WATTS BAR NUCLEAR PLANT (WBN) UNIT 1 - RESPONSE TO REQUEST FOR
ADDITIONAL INFORMATION REGARDING REQUEST FOR LICENSE AMENDMENT TO
TECHNICAL SPECIFICATIONS - SPENT FUEL POOL STORAGE CAPACITY
INCREASE (TAC NO. M96930)

WATTS BAR NUCLEAR PLANT (WBN) UNIT 1
REQUEST FOR ADDITIONAL INFORMATION
SPENT FUEL POOL STORAGE CAPACITY

Figure 2.1

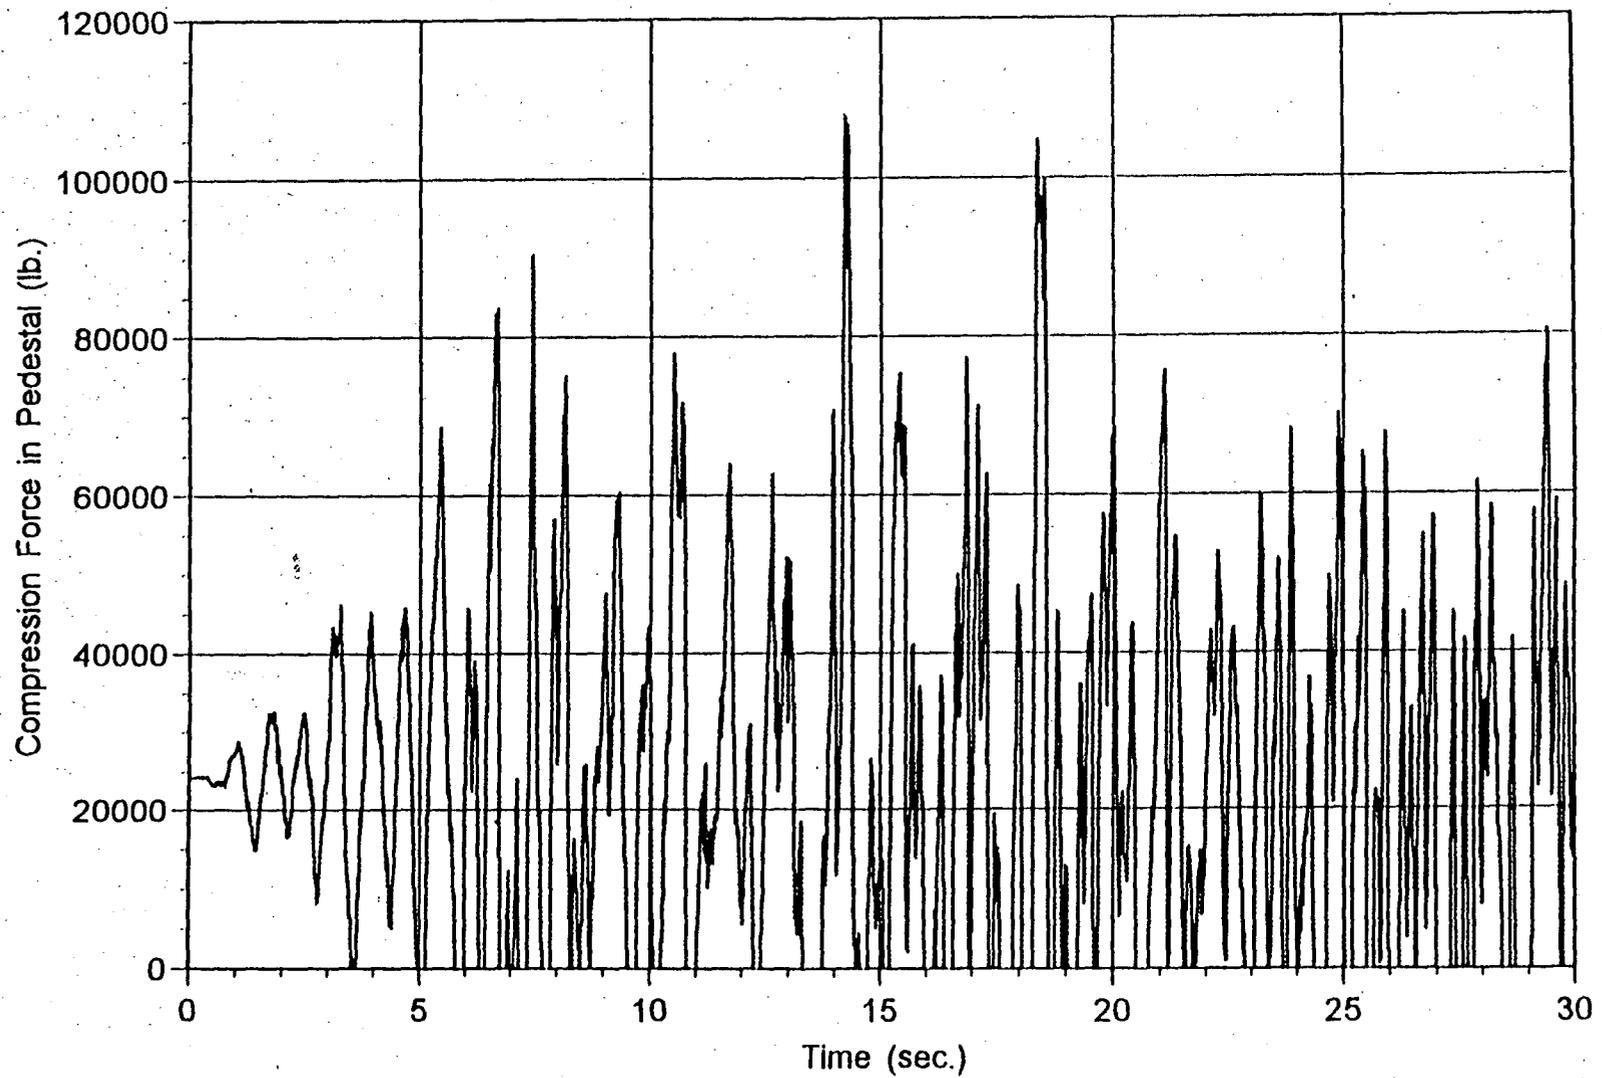
A comprehensive analysis of the results were not provided in the submittal (Reference 1) for staff review. Provide a summary of the analysis results (i.e., stresses, displacements, hydrodynamic pressure distribution, locations of the maximum responses, etc.) in a tabular form for the single- and multi-rack analyses.

The tables shown below provide the requested information. Figures 2.1 and 2.2 give representative gap and pedestal loads as a function of time.

Figure 4.1
Concrete Stress-Strain Curves

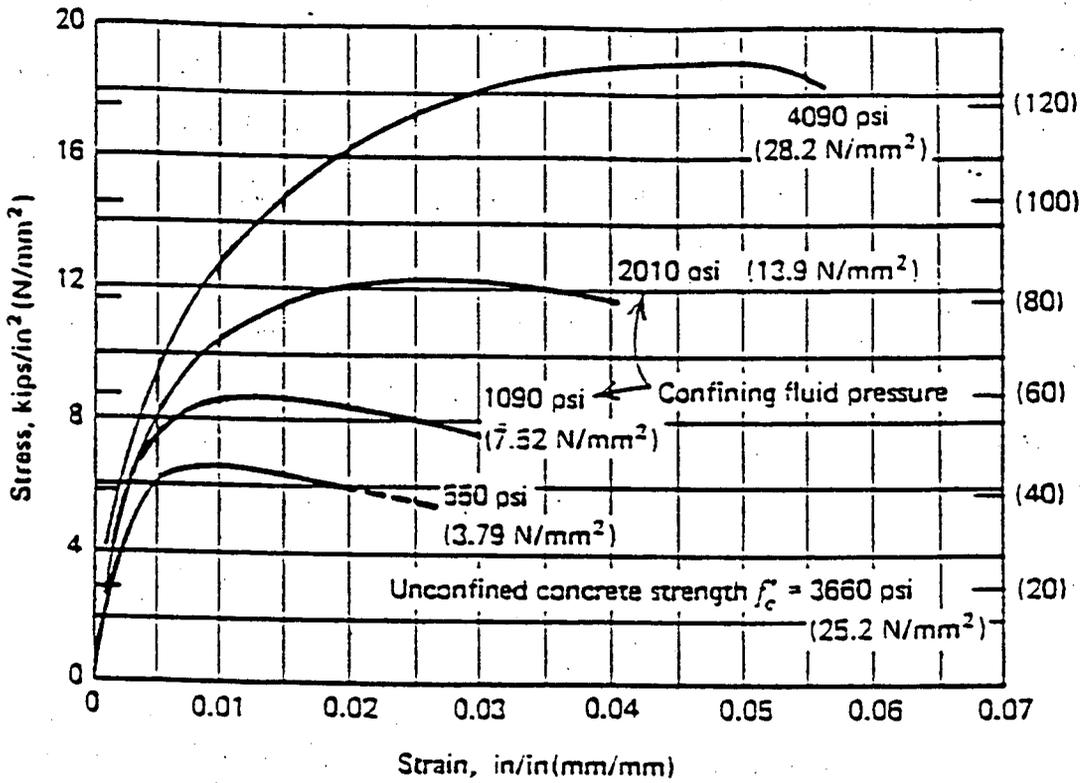
- a) analytical approaches or methodologies used,
- b) loading conditions,
- c) failure (tear and rupture) criteria
- d) material properties used including concrete bearing strength and the friction between the pedestal and liner, and
- e) complete summary of the analytical results in a tabular form.

Because the superior stratum of the concrete slab is laterally confined and simultaneously compressed from the interior of the pool by water pressure, it exhibits a tri-axial compressive stress behavior, which reduces the tendency for internal cracking. The stress-strain curve of various types of concrete subjected to tri-axial compression tests is depicted in Figure 4.1. For conservative reasons, in the absence of laboratory tests confirming a real stress-strain relationship of the pool slab concrete, the values representing the unconfined full capacity of concrete are used.

Figure 8.2

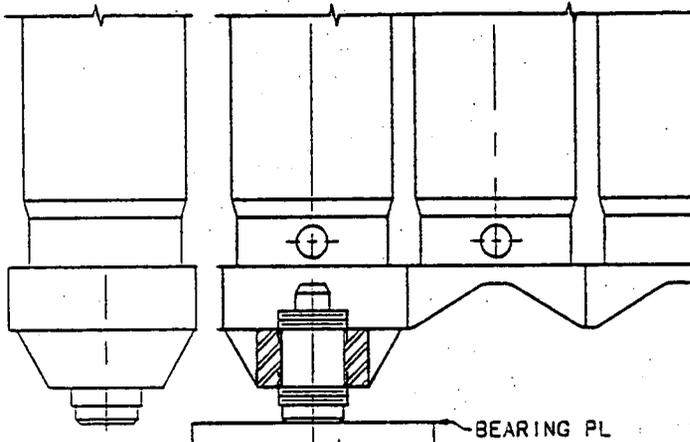
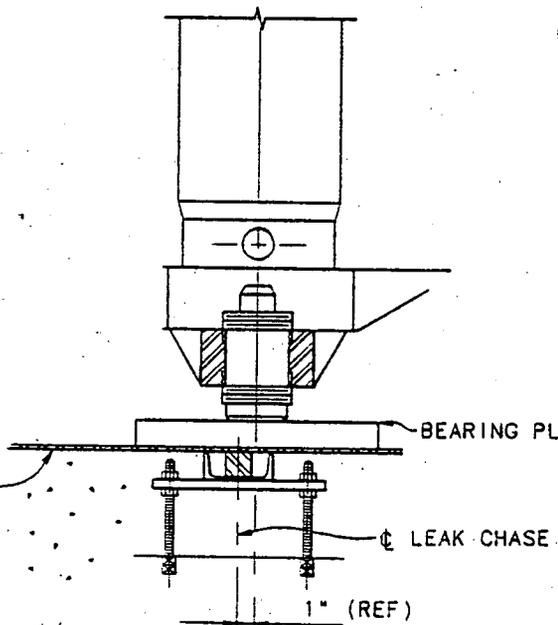
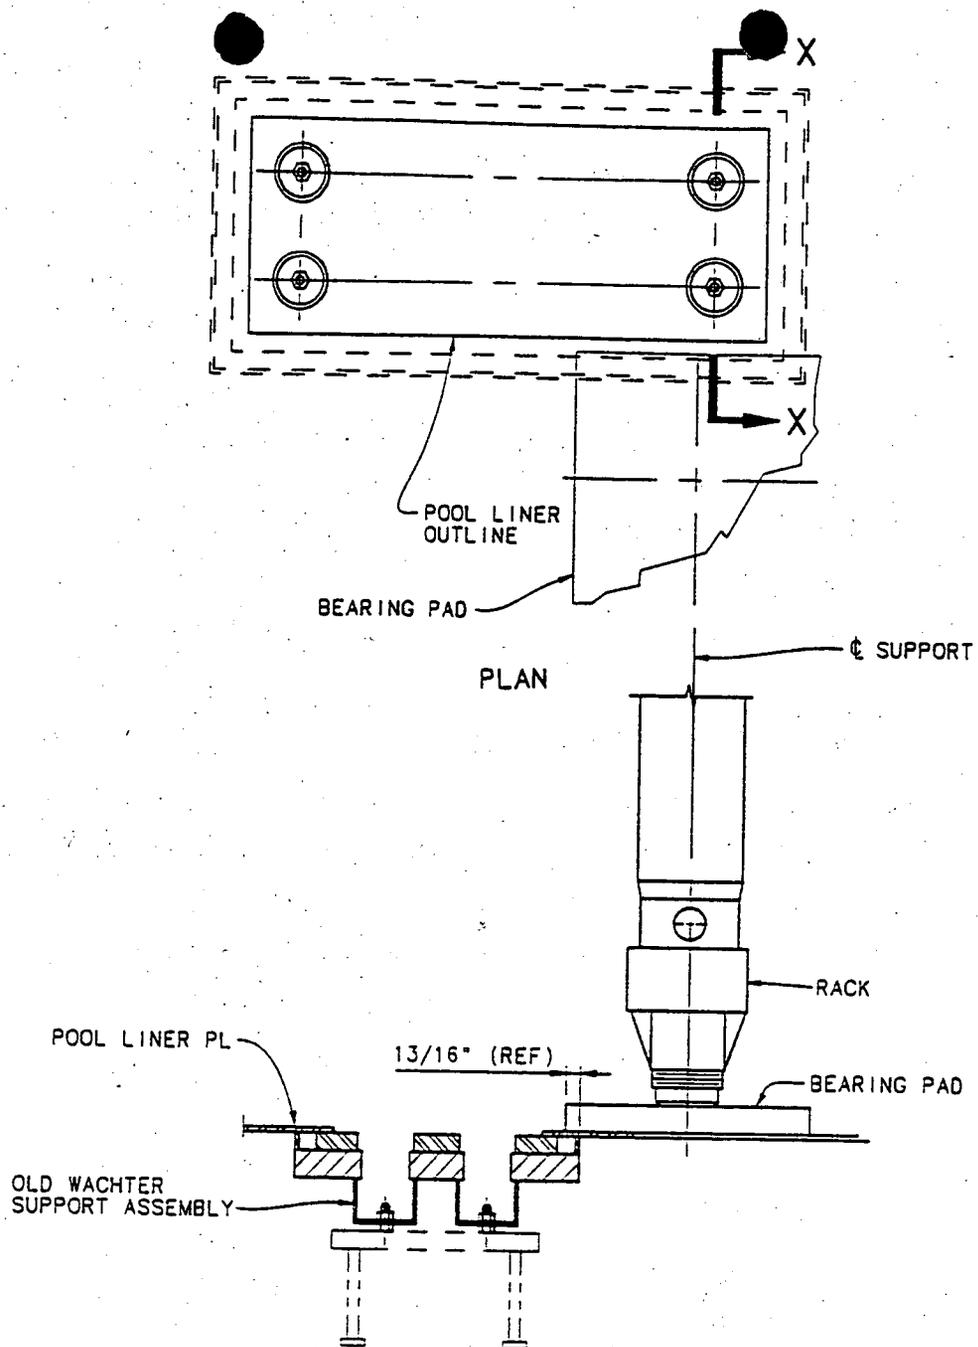
Provide the locations of the leak chase systems with respect to the locations of the racks and pedestals.

Figure 8.1 shows the layout of the racks and the leak chase system. The leak chase system in the floor of the spent fuel pool consists of leak channels around the periphery of the floor (see Figure 8.2, Section A-A), one east-west leak channel and eight north-south leak channels (see Figure 8.2, Sections B-B and C-C). The leak channel locations were considered when the rack layout was developed. However, it was not possible to avoid the leak channels entirely. Therefore, the bearing pads have been designed to ensure that the load from the rack pedestal is bridged across the leak channels and the concrete allowable stresses are not exceeded. Also, the rack layout does not cause a support pedestal to be located over the existing pits in the floor which were used for the existing rack supports (see Figure 8.3, Detail A).

Figure 9.3

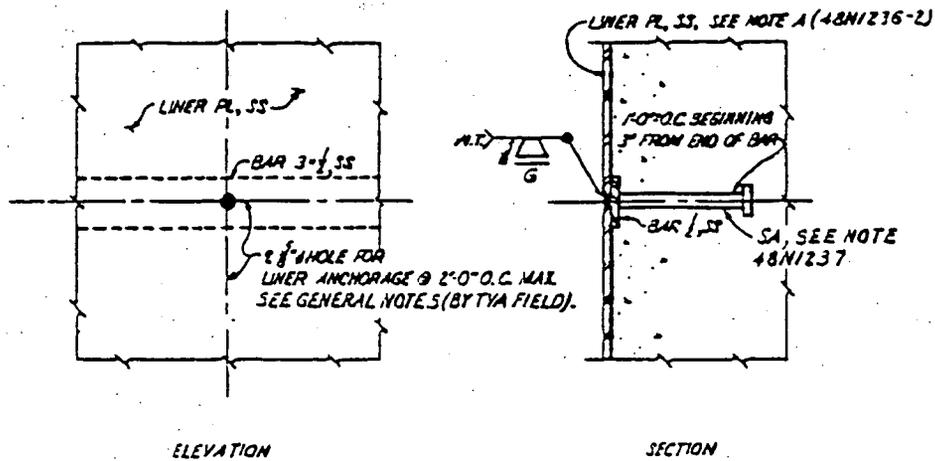
Describe how the liner plates are attached to the channels embedded in the concrete slab.

It should be noted that during the January 14, 1997 meeting with NRC, TVA incorrectly stated that plug welds were not used on the spent fuel pool liner. Plug welds were not used on the floor liner plates. However, plug welds were used on the wall liner plates. Figures 9.2 through 9.5 provide excerpts of the TVA construction drawings and show representative construction details of the liner plates. The liner plates on the floor of the spent fuel pool are not positively attached to the concrete. The plates were placed on the concrete base slab and were attached to the adjacent plates with full penetration welds at the edges of the plates. The plates for the walls were also installed after placement of the concrete with the same type leak channels and welded plate edges. The wall plate was also plug welded to horizontal embedded plates. These embedded plates are shown in Figure 9.4 and the plug weld detail is shown in Figure 9.5.
